# Access Compliance Report

## Public Rights-of-Way

### (Curb Ramps)

Intersection ID: 27763	Main Street: BALLANTYNE_CROSSING_AV	Cross Street: BRICK_CHURCH_CT	Location: W
ADA ID: A8CFC93E13B1	Ramp Type: BlendTrans1	Initial Pass/Fail: Fail	Overall Compliance: No
Severity Score: 21.25			
Codes/Mitigation Info/Possible Solution		Field Measurements/Component Compliance

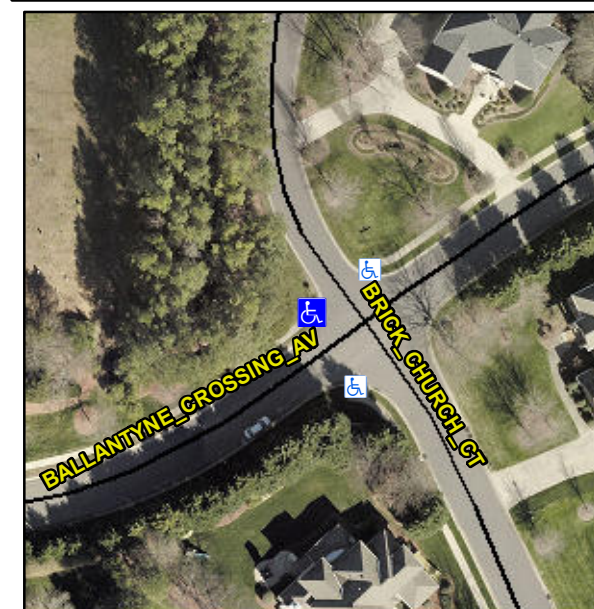
Compliance	Description	Data	Compliance	Description	Data
N/A	Ramp Length (in)	50.0	Yes	BlendTrans Slope (%)	4.3
No	Ramp Width (in)	46.0	No	BlendTrans XSlope (%)	5.5
N/A	Flare Type LT	N/A	N/A	Flare Type RT	N/A
N/A	Flare Slope LT (%)	N/A	N/A	Flare Slope RT (%)	N/A
N/A	Flare Traversable LT?	N/A	N/A	Flare Traversable RT?	N/A
N/A	Landing Length (in)	N/A	N/A	DWS Provided?	N/A
N/A	Landing Width (in)	N/A	N/A	DWS Contrast?	N/A
N/A	Landing Slope (%)	N/A	N/A	DWS Length (in)	N/A
N/A	Landing X Slope (%)	N/A	N/A	DWS Full Width?	N/A
N/A	Landing Curb? (Y/N)	N/A	N/A	DWS Offset (in)	N/A
N/A	Shared Landing?	N/A			
N/A	Gutter Ponding?	N/A	N/A	Gutter Slope (%)	N/A
N/A	Gutter Lip Ht (in)	N/A	N/A	Gutter X Slope (%)	N/A
N/A	Painted X Walk1?	No	N/A	Painted X Walk2?	No
	X Walk 1 Direction	To SE		X Walk 2 Direction	To NE
	X Walk 1 Width (in)	N/A		X Walk 2 Width (in)	N/A
	X Walk 1 Slope (%)	8.5		X Walk 2 Slope (%)	1.1
	X Walk 1 X Slope (%)	0.3		X Walk 2 X Slope (%)	5.4

N/A	Ramp inside XWalk1?	N/A	N/A	Ramp inside XWalk2?	N/A
	Road Slope (%)	5.5		Clear Space?	N/A
	Road X Slope (%)	4.0	N/A	Clear Space to XWalk (in)	N/A
N/A	Any Obstructions?	N/A	N/A	Storm Grate/Utility Hazard?	N/A
	Obstruction Type			Storm Grate/Utility Type	
		N/A			N/A
			Yes	Surface Condition? (G/P)	Good
			N/A	Curb Slope (%)	4.1

**Remove & Replace Curb Ramp With Two New Directional Ramps or Equivalent.**
